نگهداشت و افزایش تولید میدان نفتی بینک  
سطح الارض  
احداث ردیف تراکم گاز در ایستگاه جمع آوری بینک

PDMS Model Review Report (60%) - GCS

### PDMS Model Review Report (60%) - GCS

This document presents all raised issues and made decisions during 60% model review session

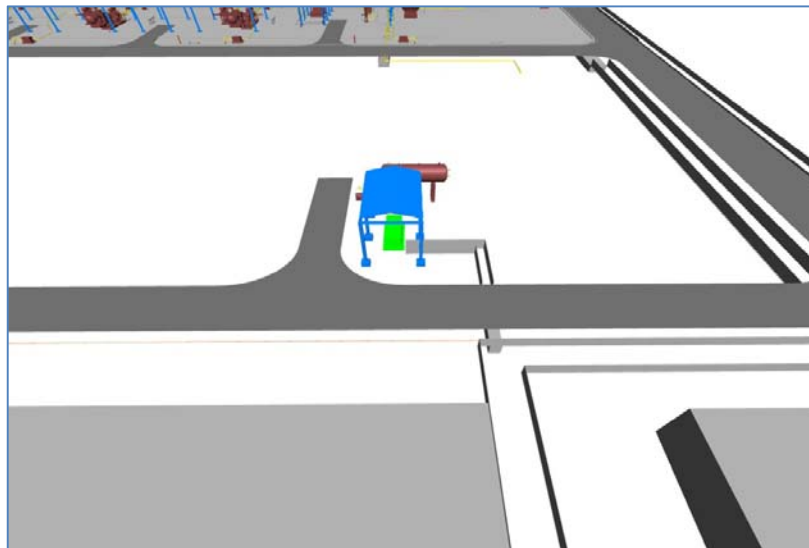
- 6.1** CLIENT stated that considering Shelter for condensate pumps should be checked with contract and responsibilities of Contractor.
- 6.2** Changing type of condensate pumps with considering NPSH and Process conditions should be reviewed by Contractor.

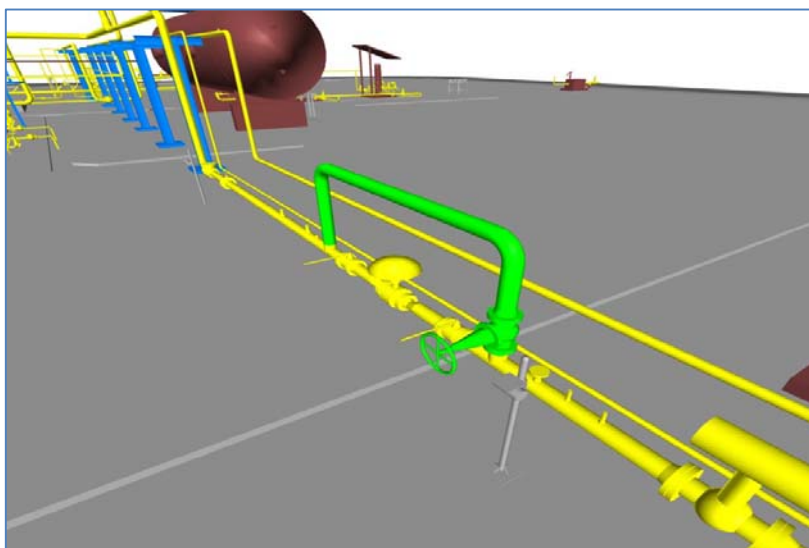
- 6.3** Shelter of Chemical Injection Packages should be rotated 90 degree and access room to be provided by moving Slug Drums to East.

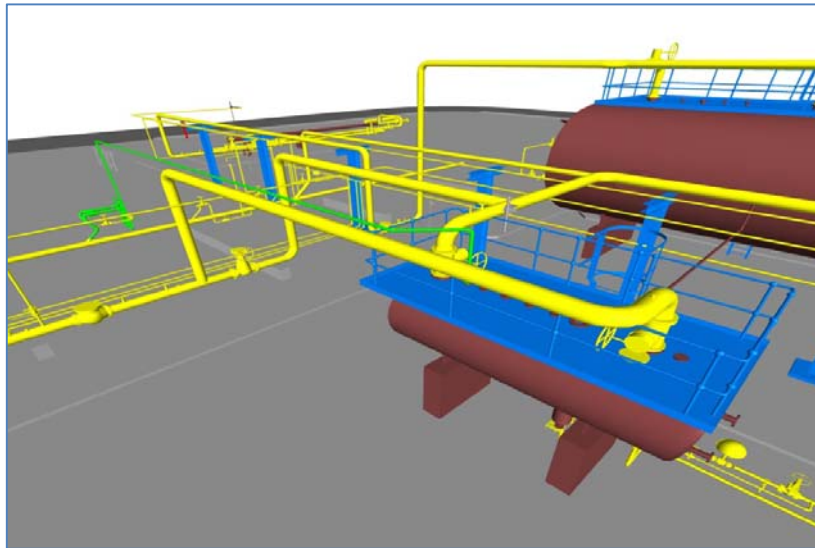
- 6.4** Regarding new proposed location of Diesel Generator by Contractor, it should be checked and finalized by Site Visit by Contractor.

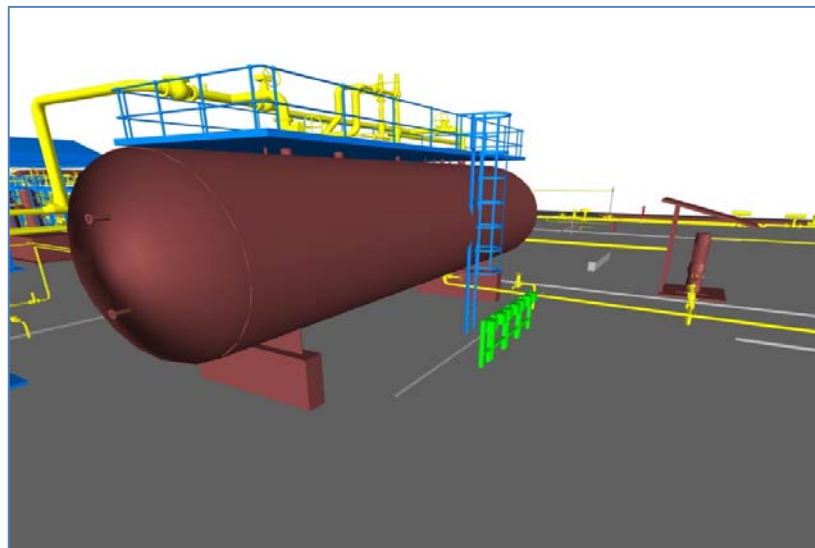
- 6.5** In Inlet Gas Line from existing Binak Cluster, Bypass of Control set to be changed from Vertical to Horizontal position.

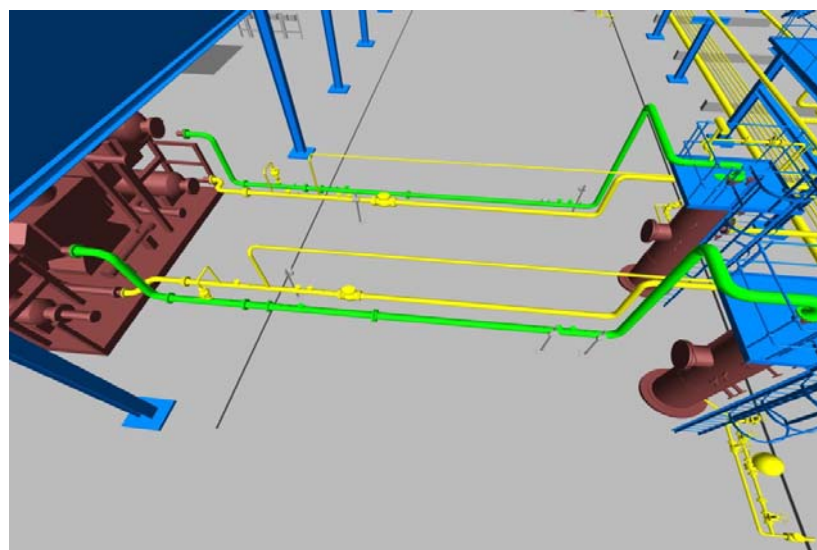
- 6.6** Pressure Safety Valves of Drum V-2105 should be installed on top of Drum, not with distance from Drum.

- 6.7** On line of Pressure Safety Valves of Drum V-2105, if Removable Spool is needed according to P&ID, it should be considered in 3D Model too.

- 6.8** Location of Junction Boxes around Slug Drum to be replaced to the other place.

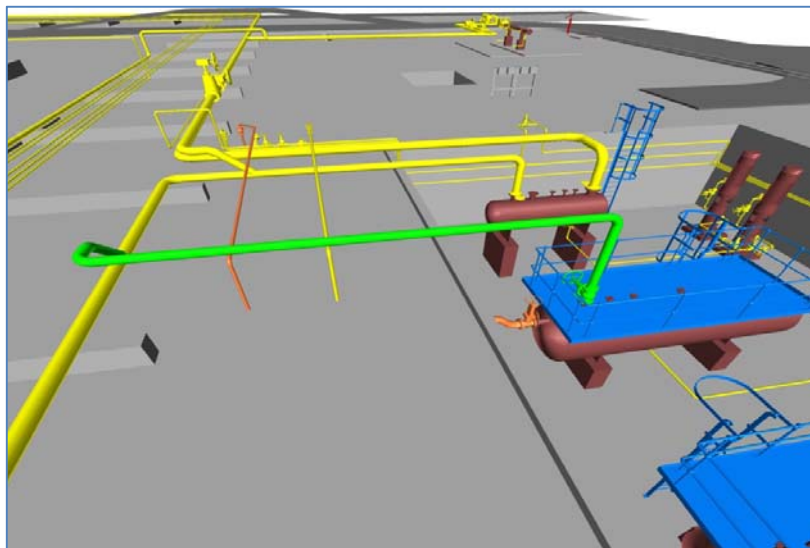
- 6.9** Because of changing the destination of outlet Condensate Line to Binak Cluster, Location of Condensate Pumps to be relocated to South area of Slug Drum and close to it.

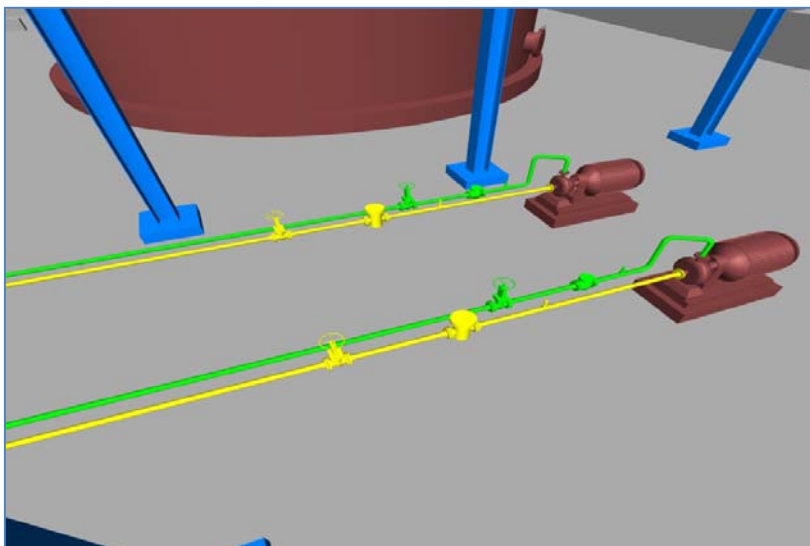
- 6.10** After receiving vendor data, Piping route of Inlet Lines of Gas Compressors for avoiding any pocket to be reviewed and if required to be modified.

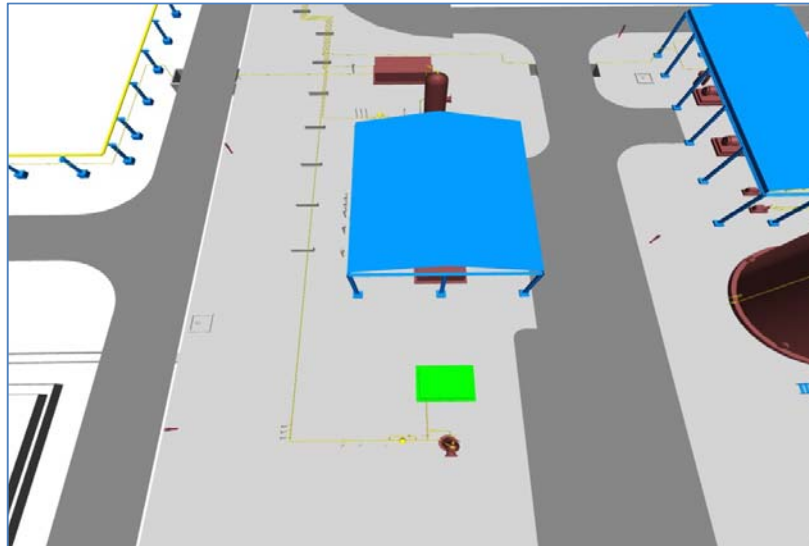
**6.12** Outlet Line of CDH Drum to be relocated to opposite side of Inlet line.

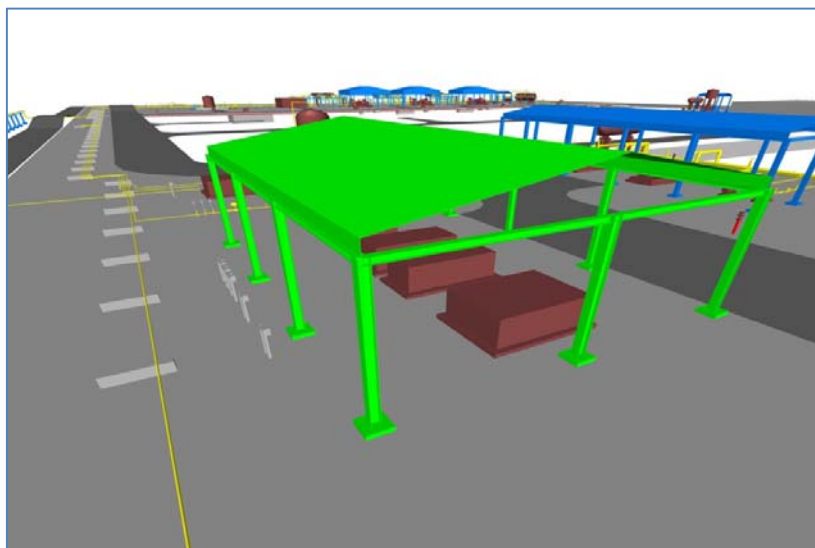
**6.13** Regarding Fire Water Jockey Pumps, it was stated that Water Hammer of fluid to be considered in piping Stress Analysis and if required suitable support to be considered for it.
